# Access Compliance Report

## Public Rights-of-Way

Intersection ID: 12316	Main Street: ASHLEY_RD	Cross Street: GREENLAND_AV	Location: SW
ADA ID: EA6B8AD3871C	Ramp Type: IslandPerp	Initial Pass/Fail: Fail	Overall Compliance: No
Severity Score: 12.5			
Codes/Mitigation Info/Possible Solution		Field Measurements/Component Compliance

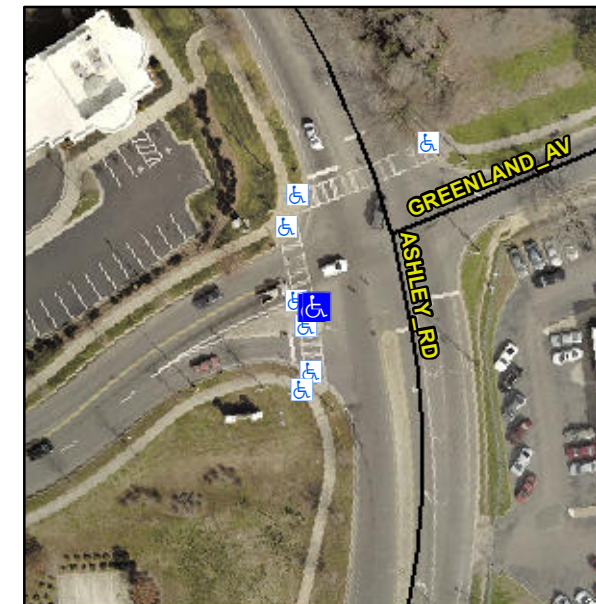
Compliance	Description	Data	Compliance	Description	Data
N/A	Ramp Length (in)	63.5	No	Ramp Slope (%)	9.1
Yes	Ramp Width (in)	48.0	Yes	Ramp XSlope (%)	0.9
N/A	Flare Type LT	N/A	N/A	Flare Type RT	N/A
N/A	Flare Slope LT (%)	N/A	N/A	Flare Slope RT (%)	N/A
N/A	Flare Traversable LT?	N/A	N/A	Flare Traversable RT?	N/A
N/A	Landing Length (in)	N/A	N/A	DWS Provided?	N/A
N/A	Landing Width (in)	N/A	N/A	DWS Contrast?	N/A
N/A	Landing Slope (%)	N/A	N/A	DWS Length (in)	N/A
N/A	Landing X Slope (%)	N/A	N/A	DWS Full Width?	N/A
N/A	Landing Curb? (Y/N)	N/A	N/A	DWS Offset (in)	N/A
N/A	Shared Landing?	N/A			
N/A	Gutter Ponding?	N/A	N/A	Gutter Slope (%)	N/A
N/A	Gutter Lip Ht (in)	N/A	N/A	Gutter X Slope (%)	N/A
N/A	Painted X Walk1?	No	N/A	Painted X Walk2?	N/A
	X Walk 1 Direction	To E		X Walk 2 Direction	N/A
N/A	X Walk 1 Width (in)	N/A	N/A	X Walk 2 Width (in)	N/A
	X Walk 1 Slope (%)	0.4		X Walk 2 Slope (%)	N/A
	X Walk 1 X Slope (%)	0.6		X Walk 2 X Slope (%)	N/A

**Remove & Replace Entire Ramp.**
